our reference: 22000129-R-02
your reference:

Review of Surface and Ground Water Quality: Windsor Bridge

As requested, SEEC has coordinated a review of the Water Quality Management Program (WQMP) for the Windsor Bridge Replacement Project prepared by Jacobs on behalf of Transport for NSW. The WQMP describes the required water quality sampling and testing regime to determine if the proposed construction of the new bridge over the Hawkesbury River at Windsor has impacted local surface and ground water environments.

Figure 2: Example dry weather plots for pH at the north bank locations, construction phase.

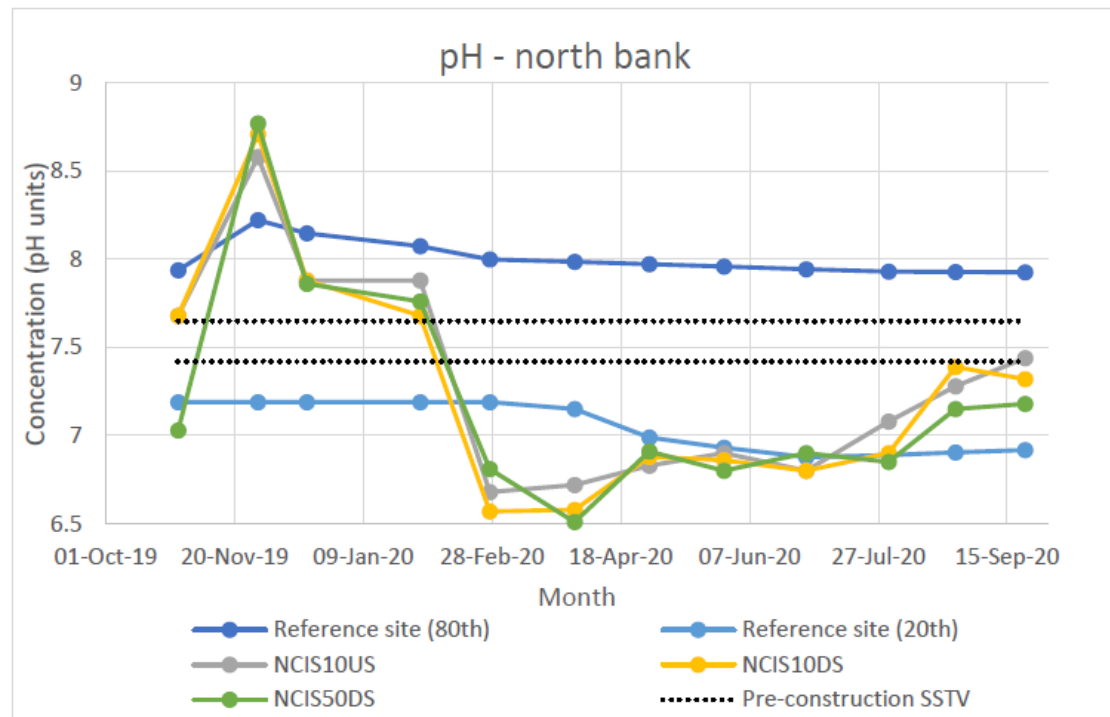
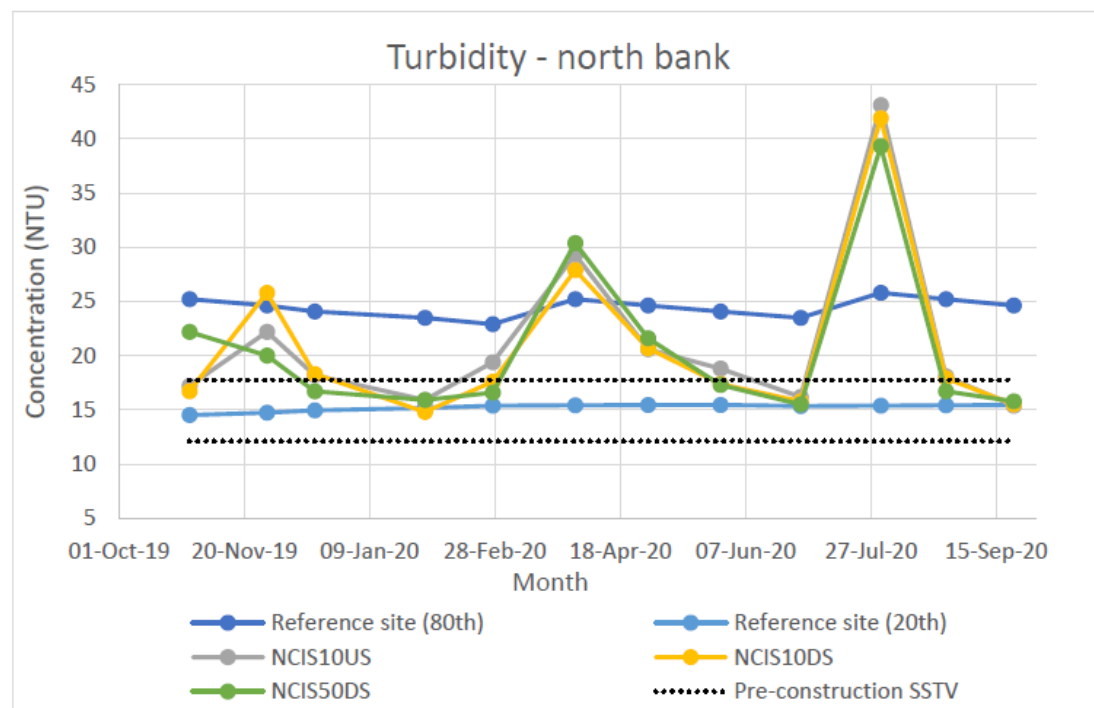
The Jacobs report highlighted that although the SSTVs were not met, on most occasions the pH levels were within ANZECC trigger values and were only

exceeded during large rainfall events. Turbidity levels were lower than the ANZECC trigger values and were generally within the SSTVs except after significant rainfall events.

Figure 4: Plot of pH at the north bank locations, post construction phase.

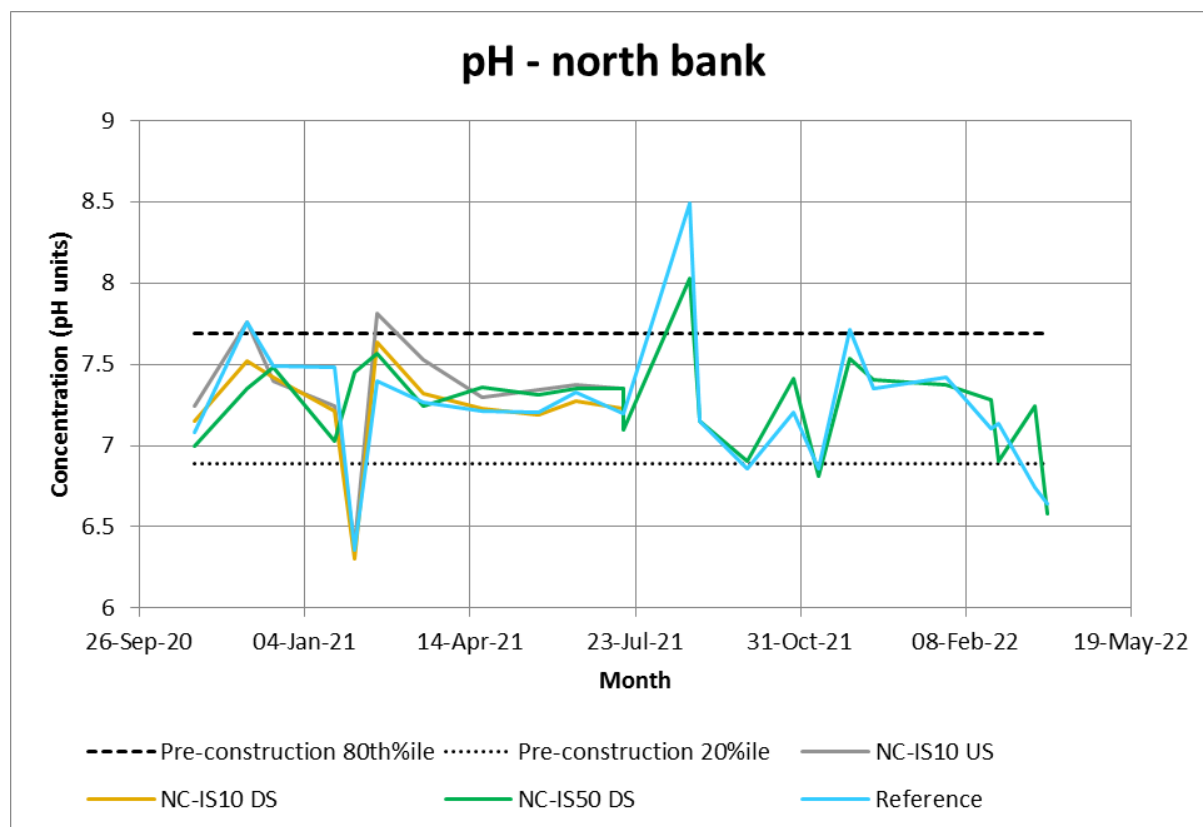
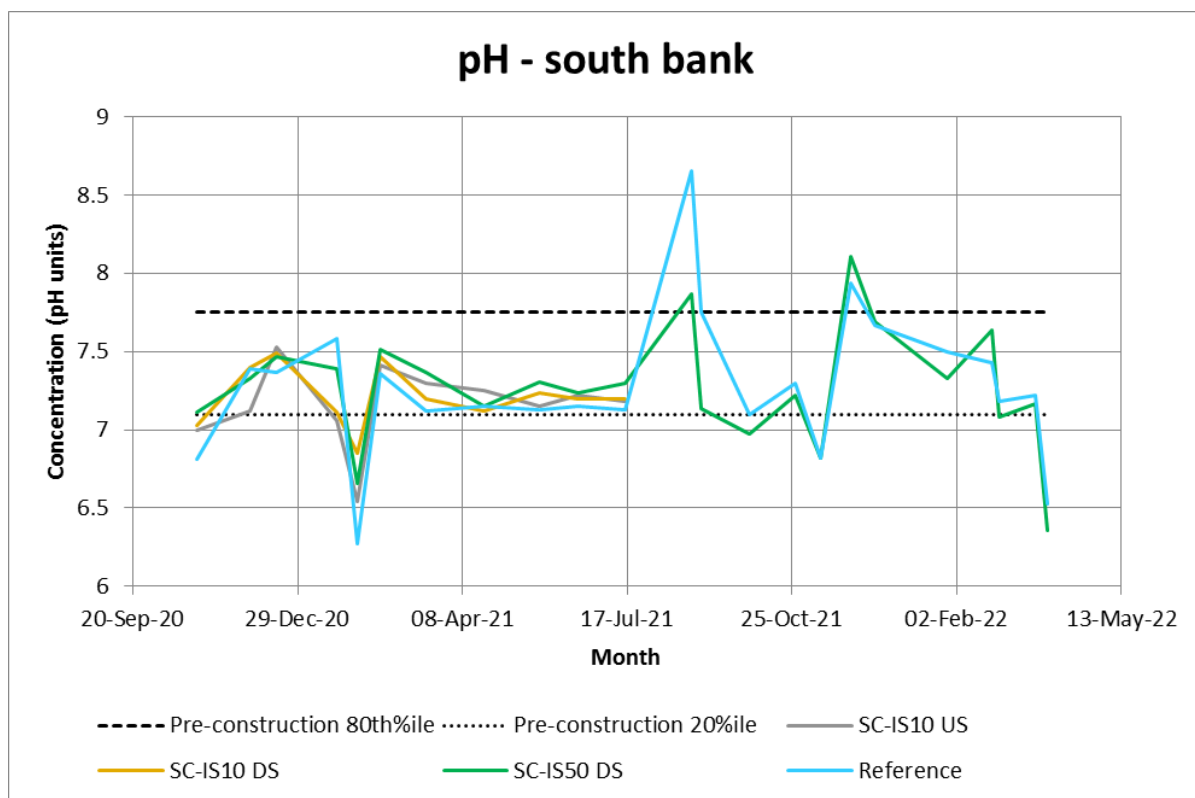
Based on the data in Figure 4, pH is generally within the pre-construction SSTVs and within the ANZECC guideline values (8.5-6.5) except for 6.39 on 3 February 2021 and 6.29 on 22 March 2022, both of which were wet days. pH also decreased at the upstream reference site indicating that the variation was unlikely to be due to the Windsor Bridge project.

Figure 6: Plot of Turbidity at the north bank locations, post construction.

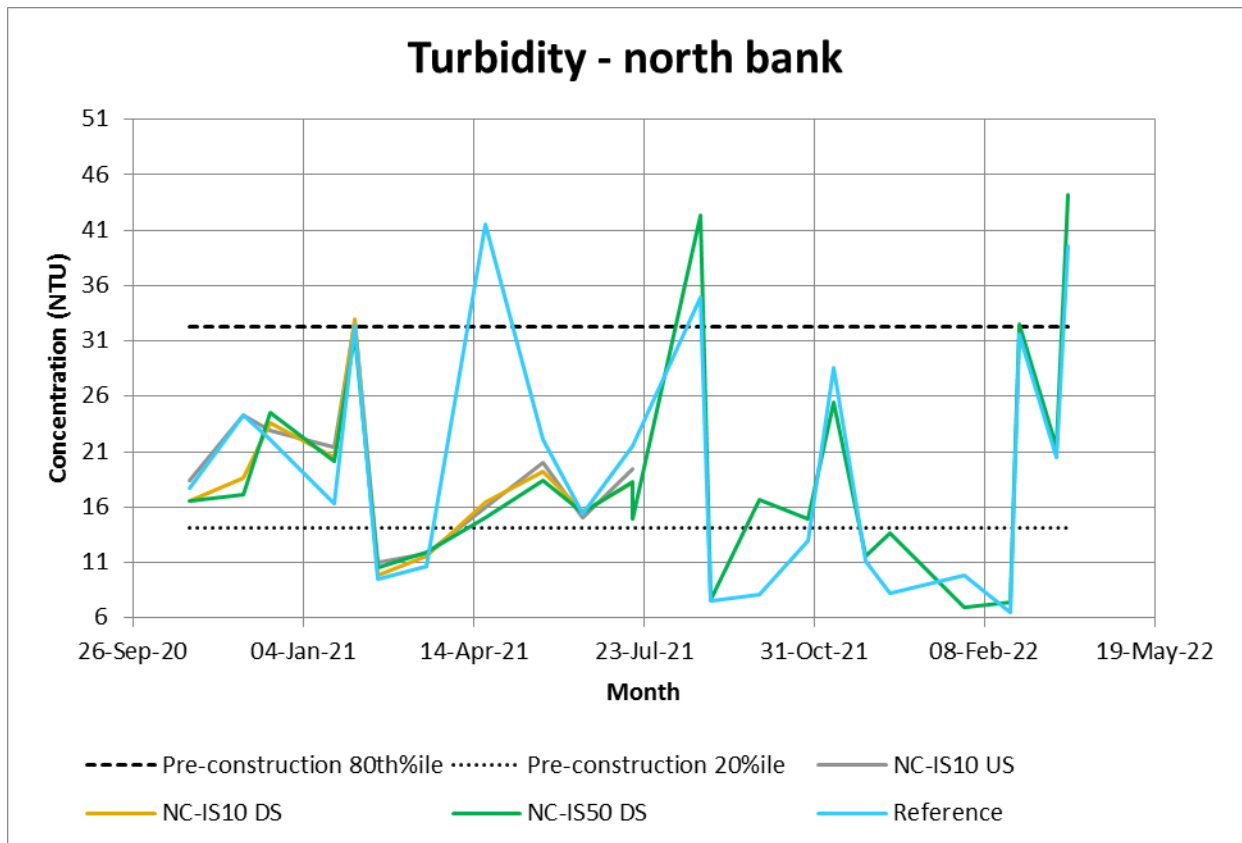
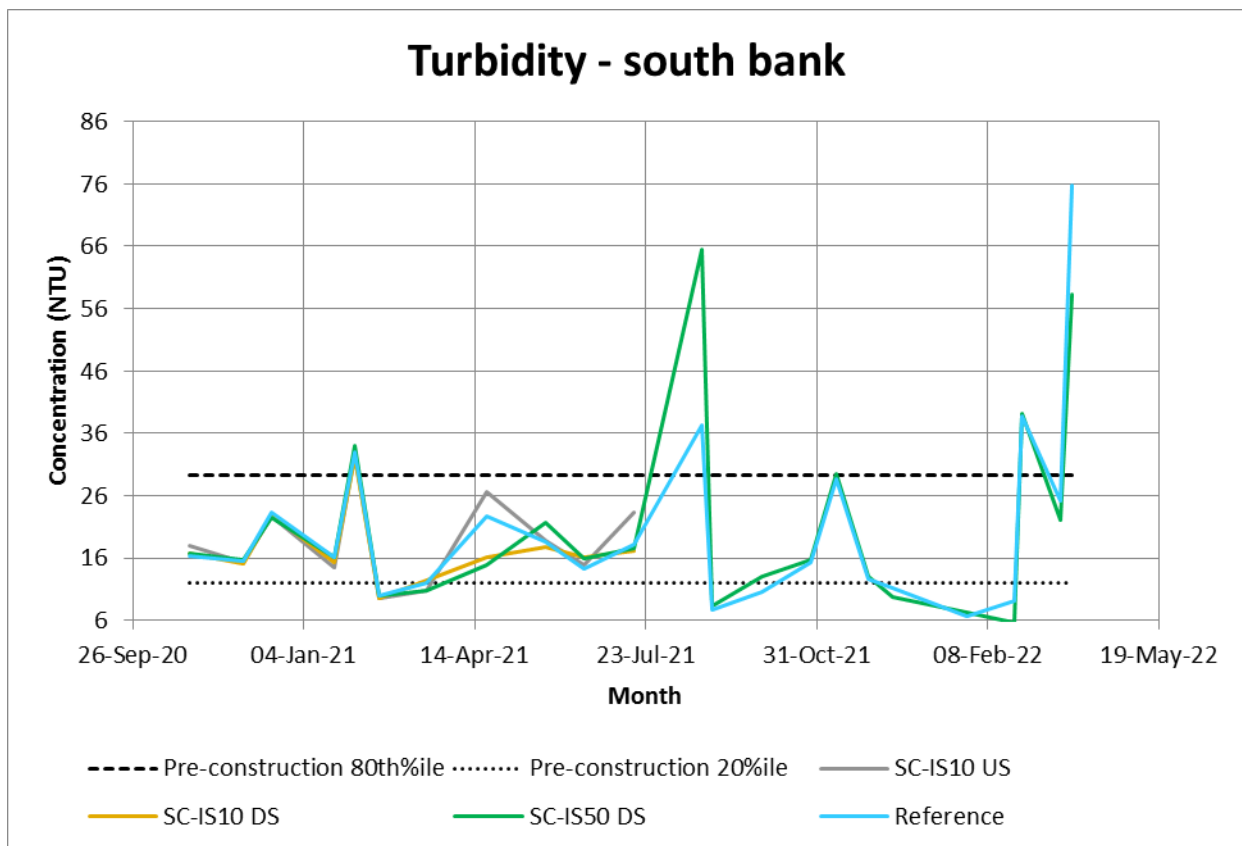
Turbidity was generally within the SSTVs and was lower than the ANZECC guideline value of 50 NTU. Turbidity only exceeded the SSTVs following rainfall and matched the change in turbidity observed at the upstream reference site.

The south bank impact site 50m downstream of the bridge had two instances where turbidity exceeded the ANZECC trigger value. Both were following significant rainfall events in August 2021 and March 2022. The downstream turbidity during the August event exceeded the upstream reference site turbidity however the March event did not. This increase could have been due to exposed soil at the project site however given the possibility that turbidity could have been derived from surrounding agricultural lands, it is not possible to confirm this. Furthermore and as noted above, this anomaly was not repeated during the March 2022 wet weather event.

Several other high rainfall events occurred after the August 2021 round of monitoring, and the turbidity at the project impact site was consistently less than the reference site. This indicates that, if the August 2021 increase was due to construction activities, it had been resolved, possibly by the completion of works and the application of ground cover to limit erosion.

Figure 8: Plot of Dissolved Oxygen at the north bank locations, post construction.

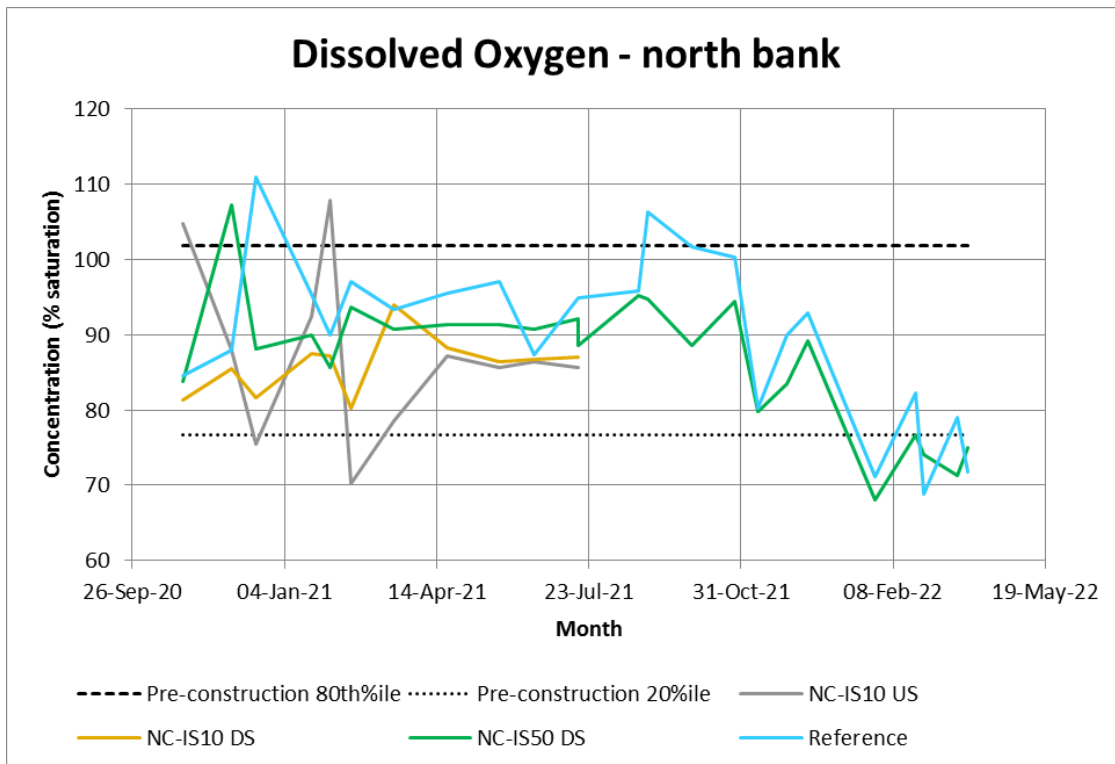
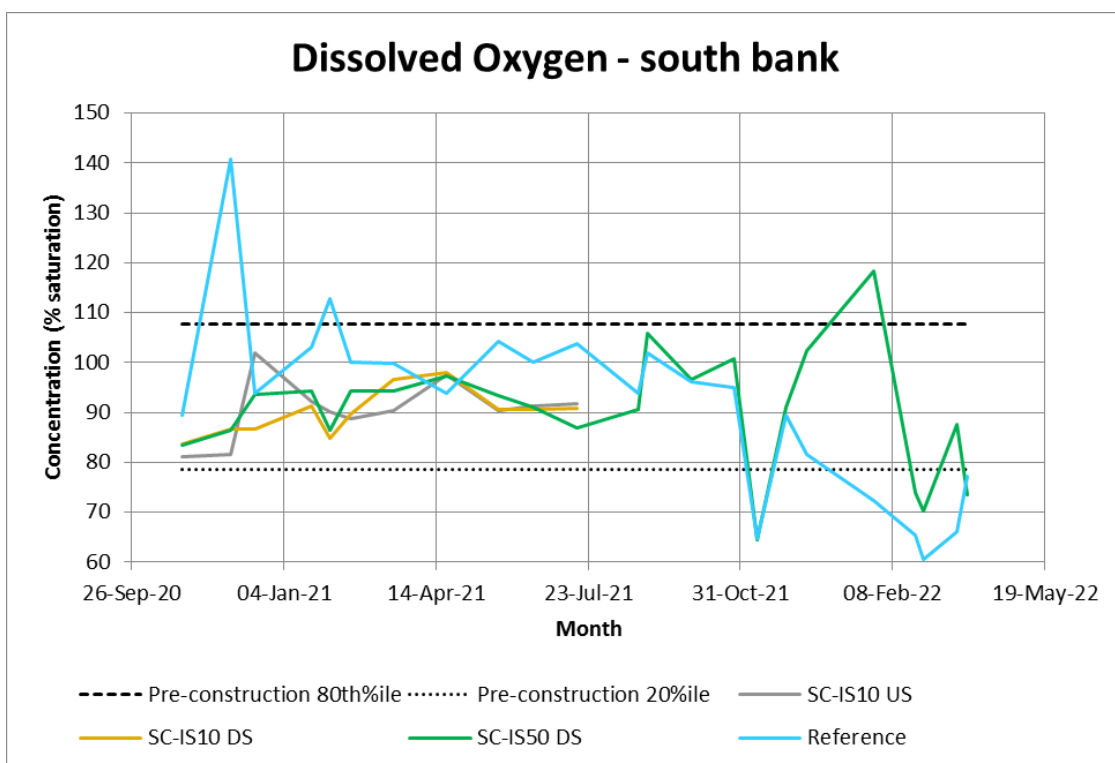
Dissolved oxygen was generally within the SSTVs. Values dropped below the SSTVs at the north bank between February and March however this trend also occurred at

the reference site indicating that it is unlikely that the project was the cause for the observed change in dissolved oxygen levels.

Figure 10: Plot of Total Nitrogen concentrations at the north bank locations, post construction.

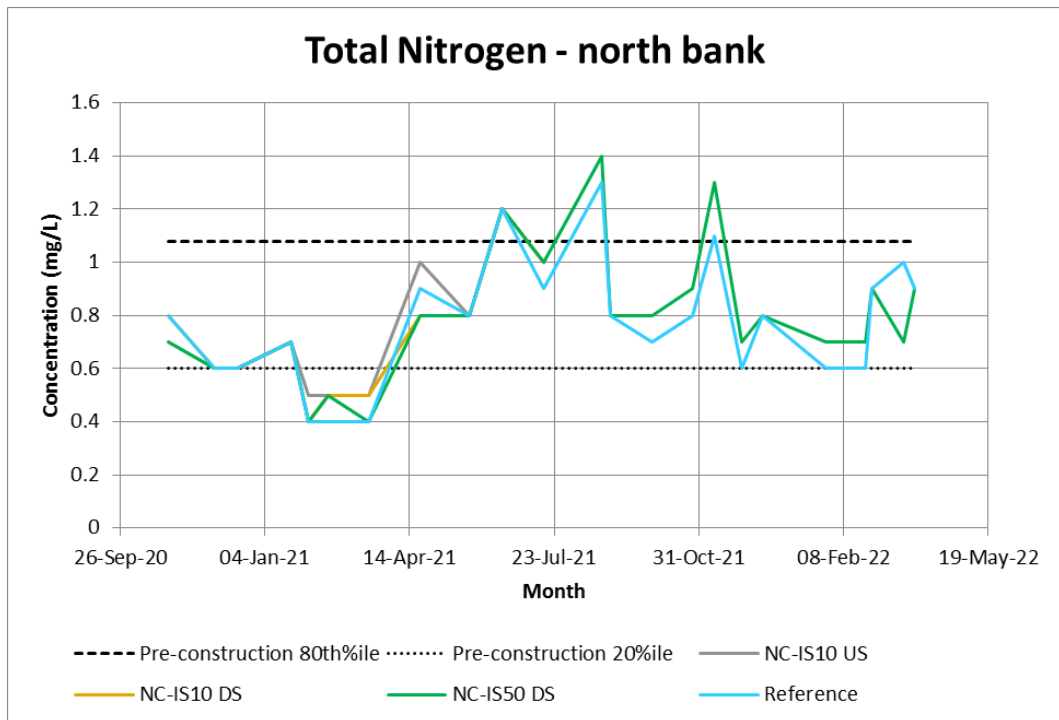
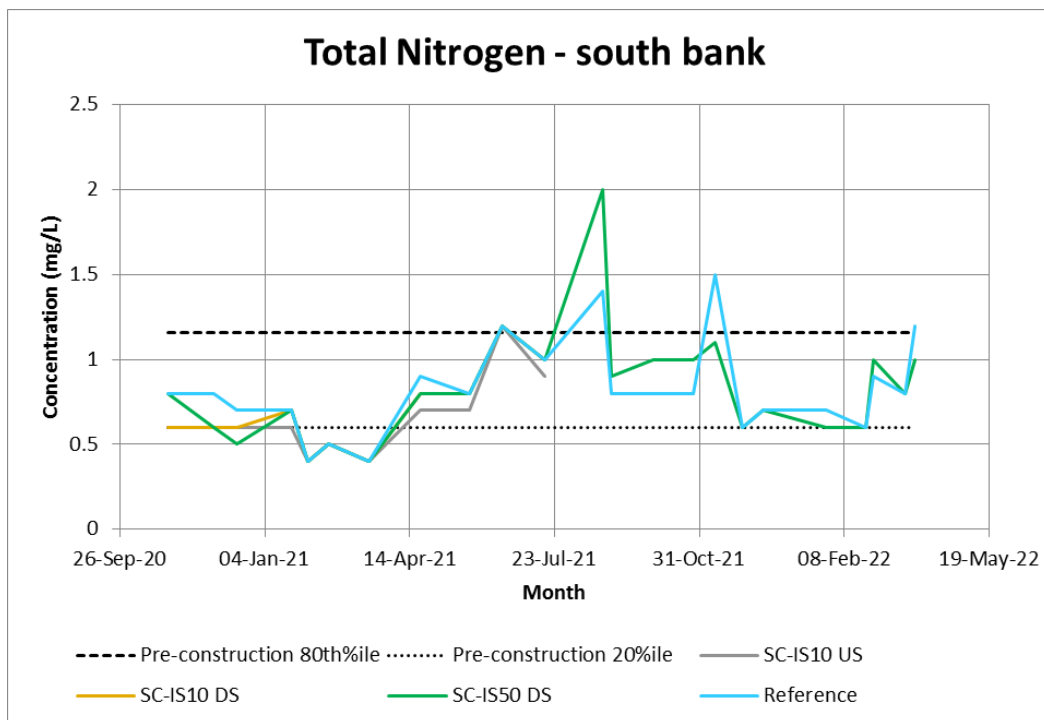
Total nitrogen levels exceeded the ANZECC trigger value of 0.35mg/L but were generally within or below the SSTVs. Observed increases occurred after rainfall events apart from the elevated value observed on 17 June 2021. However this increase also occurred at the reference site indicating that it is unlikely that the

project was the cause for the observed change in nitrogen concentrations. The south bank had a spike on 25 August 2021 following a significant rain event. It is unclear if this was due to the project, and we noted that nitrogen levels were below the reference site for all subsequent rain events.

Figure 12: Plot of Total Phosphorus concentrations at the north bank locations, post construction.

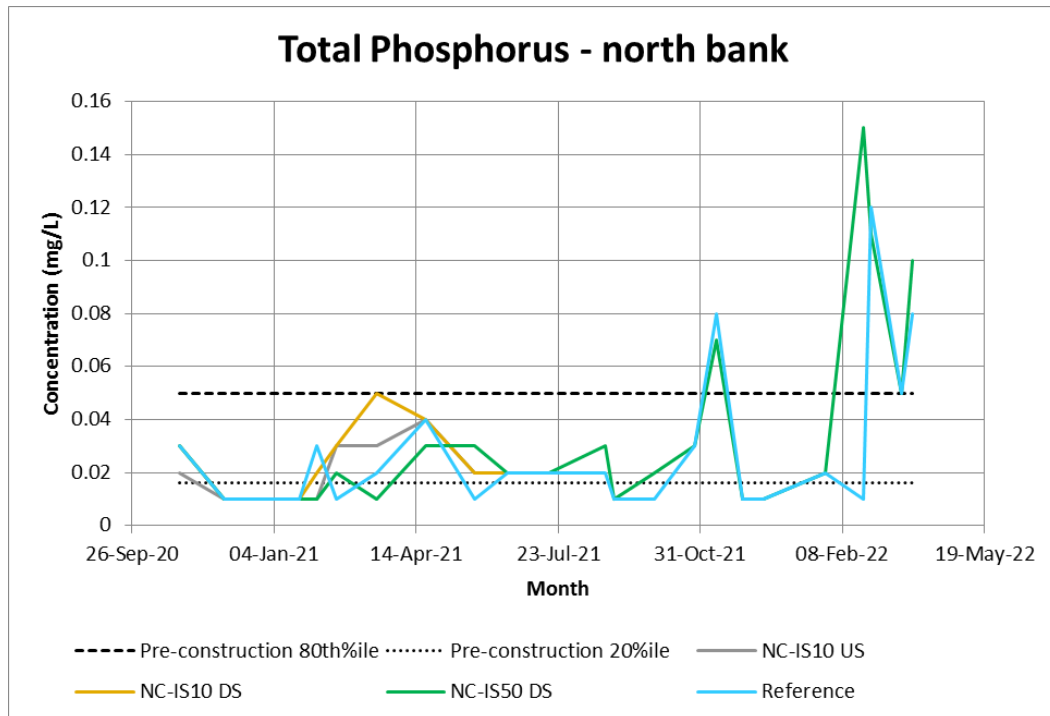
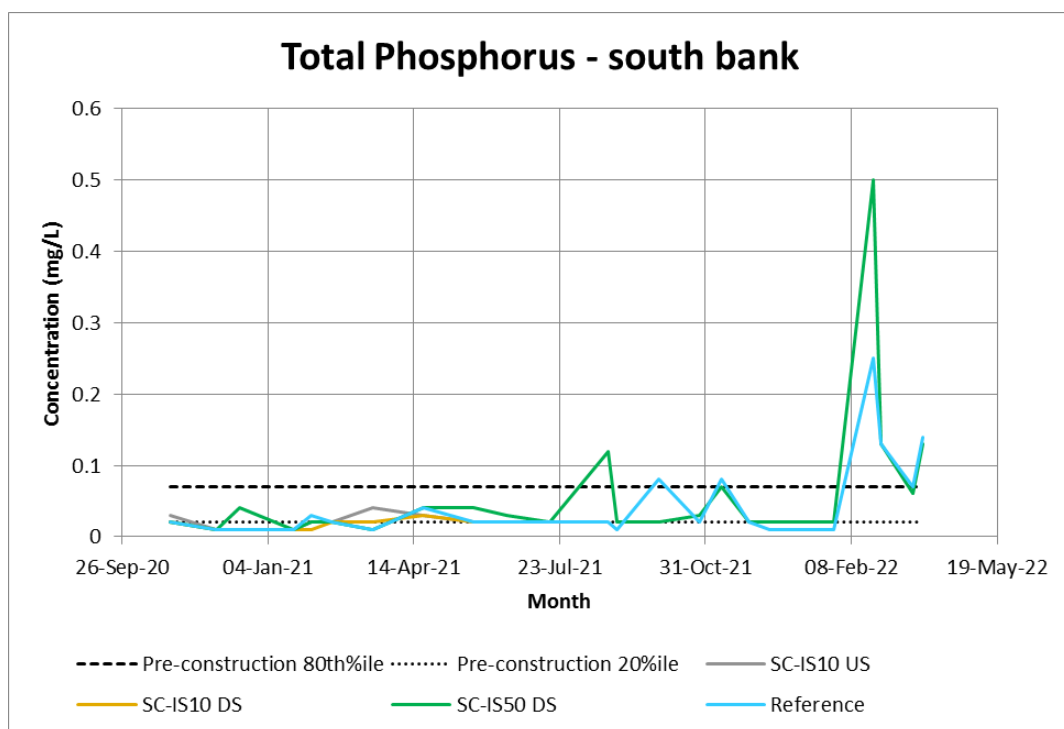
Total phosphorus levels exceeded the ANZECC trigger value of 0.025mg/L several times but were generally within the SSTVs. Observed increases occurred after rainfall at both the impact sites and at the reference site. The spike after the rainfall event on 23 February 2022 exceeded the reference site increase however the recorded value at SC-CS2 (upstream south bank wet weather site) had a Total Phosphorus value of 0.51mg/L which was more than the value recorded downstream. As any increases also occurred upstream or at the reference site it is unlikely that the project caused any change in observed phosphorus concentrations.
